RE: Carmel Ridge Subdivision 9154 Carmel Ave. NE Engineer's Certification – Not Accepted Engineer's Stamp Date: 3/1/17 Certification Dated: 6/20/18 Hydrology File: C20D075

Re: C20D075 - Carmel Ridge Subdivision Drainage Certification

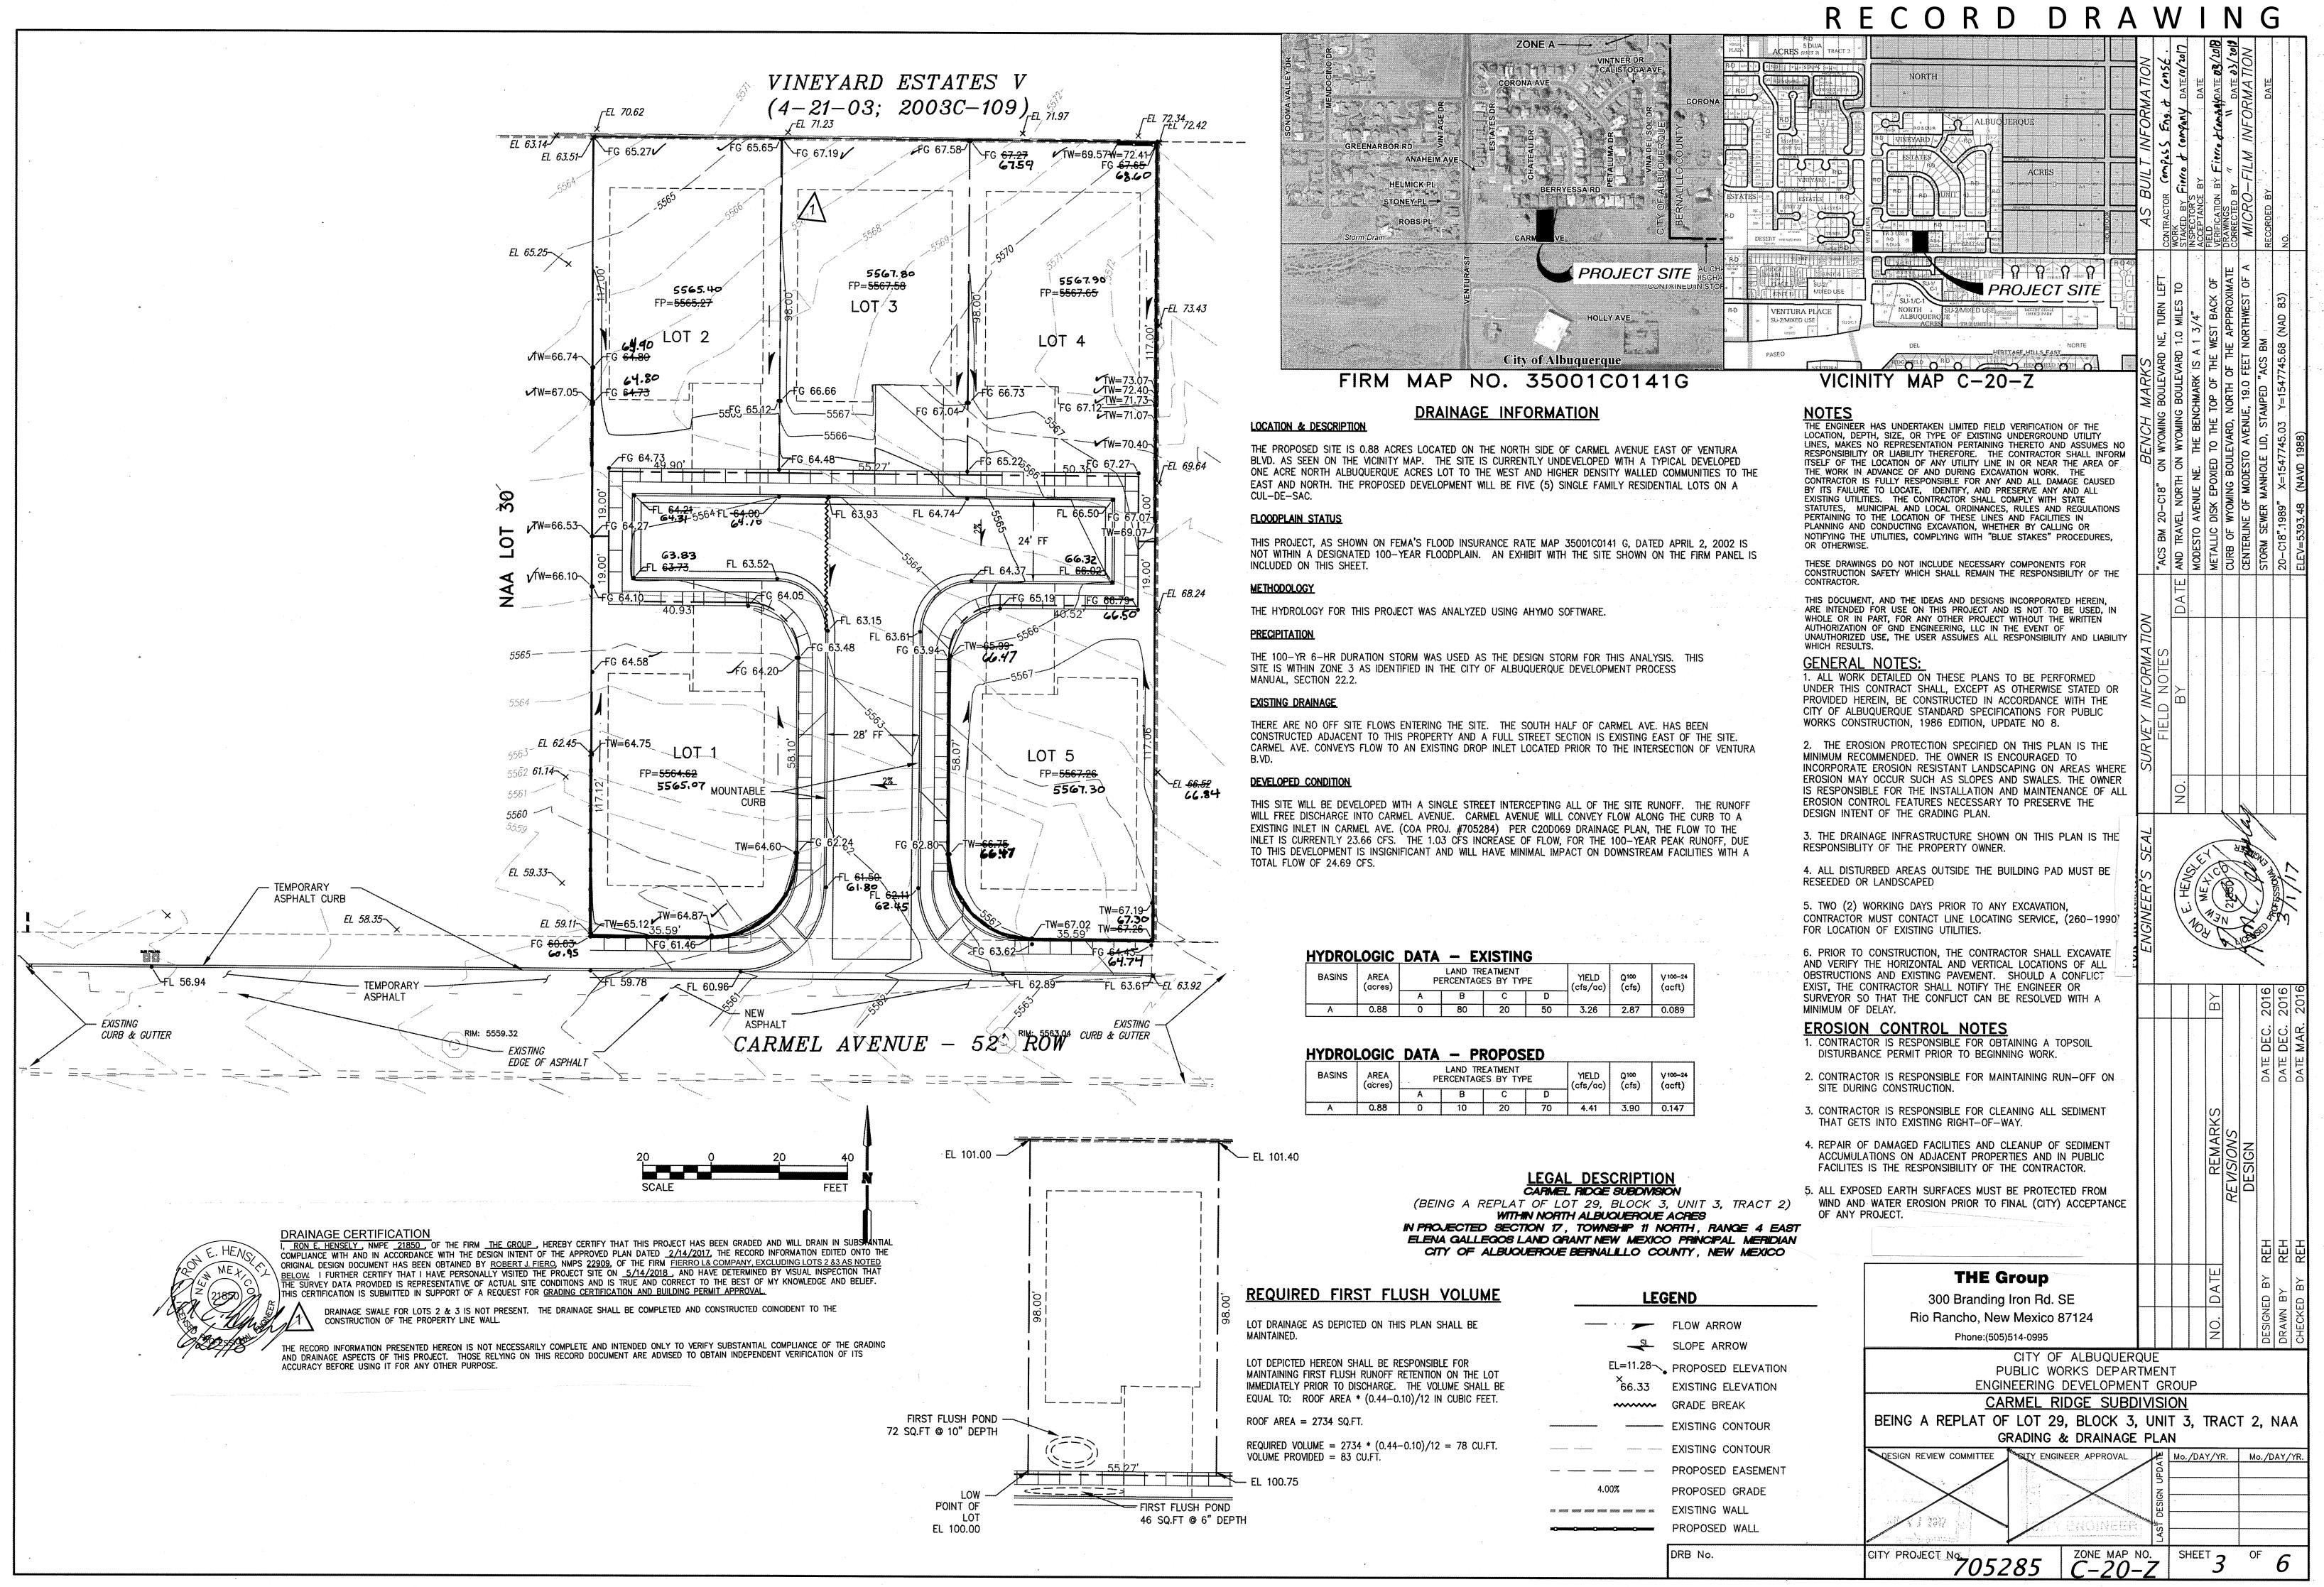
PO Box 1293
 Based on the submittal provided on 6/22/18, this Engineer's Certification cannot be approved for SIA Release or Pad Certifications until the following are addressed:
 Albuquerque
 Corrective action must be taken along the eastern edge of this subdivision:

a. The excess fill will need to be removed and graded according to the approved plan. The recent grading is inadequate; the footer is still exposed at the end of the hammerhead and

- there is still excess fill placed against the garden wall.b. Provide complete survey data of both sides of the walls (both the existing garden wall and the new retaining walls) adjoining Visalia Way.
- www.cabq.gov 2. A

2. A retaining wall or stable slope (see DPM Ch. 22.5.A: *Slope Criteria*) is required between Lot 1 and Carmel Ridge Way. The slope is still erosive and there is still dirt over the sidewalk. If electing to use a new garden wall to stabilize this slope, it will need to be constructed and the post-construction survey will need to demonstrate that there is less than 2' of grade change and the flow line is not along the wall.

3. A retaining wall is required between Lot 3 and Lot 4 and Lot 3 needs to be graded to drain the front, not into Lot 4. If electing to use a new garden wall to serve this purpose, it will need to be constructed and the post-construction survey will need to demonstrate that there is less than 2' of grade change and the flow line is not along the wall.

Corrective grading has been completed on Lot 5, and additional as-built information has been included.

- A retaining wall or stable slope is required between Lot 1 and Carmel Ridge Way. The slope is stable, and sediment control has been installed to protect the sidewalk. A wall will be constructed with development of the lot.
- 3) *A retaining wall is required between Lot 3 and Lot 4 and Lot 3 needs to be graded to drain the front, not into Lot 4.*

The condition of Lot 3 draining onto Lot 2 will be corrected with the installation of the property line wall in conjunction with house construction. Given the elevation difference of less than 2 feet, the wall was not noted as a retaining wall on the plan. Given that the wall has not yet been constructed, I have exclude Lots 2 & 3 from the certification.
